SUMMARY OF SPECIAL INSP. -RELATED INFORMATION

DIABLO CANYON

Characterization: H. P. FOLEY USED/USES UNQUALIFIED WELDERS AND UNQUALIFIED WELDING PROCEDURE SPECIFICATIONS

NONCONFORMANCE REPORT

PS-2 LCP-3A

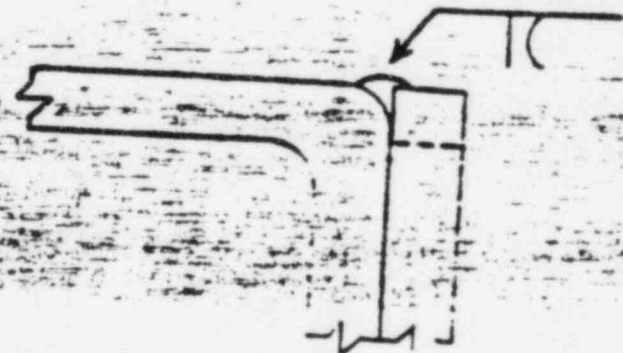
DESCRIPTION OF NONCONFORMANCE: (Including Cause) The Procedure QCP-5A, WPS-62 is not in accordance with the Code AWS DL1. This Joint Configuration is not prequalified per AWS DL1-82 or any other Code year. If this Joint has been qualified by H. P. Foley it is not noted, also which is not noted are the Joint Details, such as material thickness, root opening, radius, etc., so it is not known what material this WPS is to be used on or, have been used on.

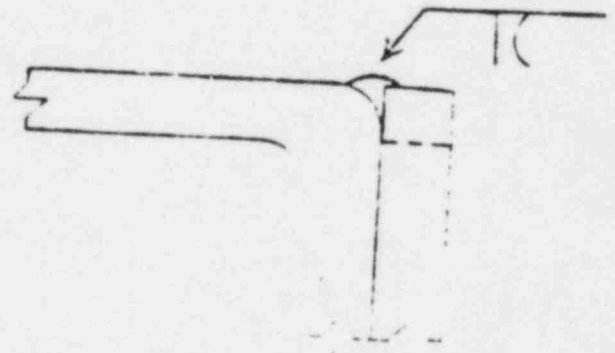
DESCRIPTION OF NONCONFORMANCE: (Including Cause) The Procedure QCP-5A, WPS-62
details a dashed horizontal line on the vertical item on the right side of the
sketch. It is not known the intent of this dashed horizontal line. If the WPS is
showing the effective throat of the weld then this is indeed a Non-conforming
condition for it is excessive (Joint penetration) detailed on the WPS. It is not
known what material this WPS is to be used on, or has been used on.
CONTINUED ON PAGE 2:

NOTE# 1: Actual Joint Detail performance tests are required per AWS D1.1-82. The Joint Detail and Welding Variables (i.e. Electrode size, Amps, Volts, Welding positions, Root opening, etc.) should be shown on the W.P.S.

NEW FIX FOR SUPPORT NO. 6SR-127-4-52
DETAIL 3-190

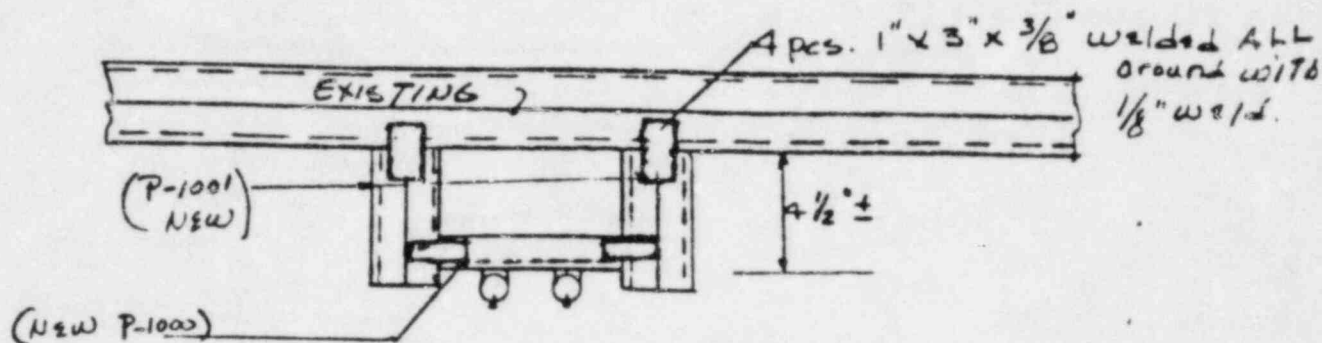
Problem On detail S-190 (CSR-127-4-52) the recommended "fix" can not be done. Do you have an alternate method?

1. We cannot modify support per detail 3-190 as supplied by Engineering. Above sketch is suggested. Do you concur?

FOR Support No. CSR-127-6-343 Detail S-42
PER DCI-EC-3604-4 and W.R. E-1238

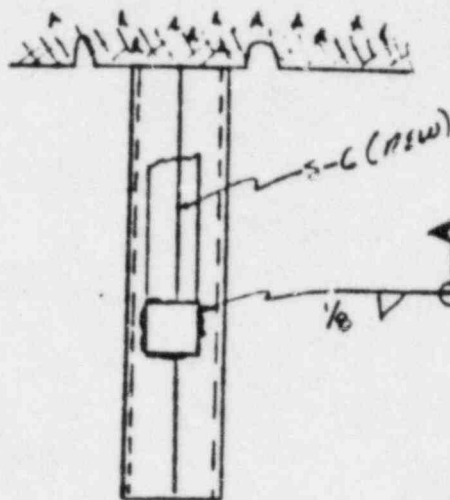
On detail S-428 (CSR-127-6-343) the weld symbol shows we have to weld all the way around. Can we weld on three sides only?

(Proposed) ① Because
of space limitation we
can only weld 3 sides
(bottom & 2 sides),
Is This good enough ?

1. Welding 3 sides of the S-6 brace is good
enough. PER ED EPSTEIN (OPEG)
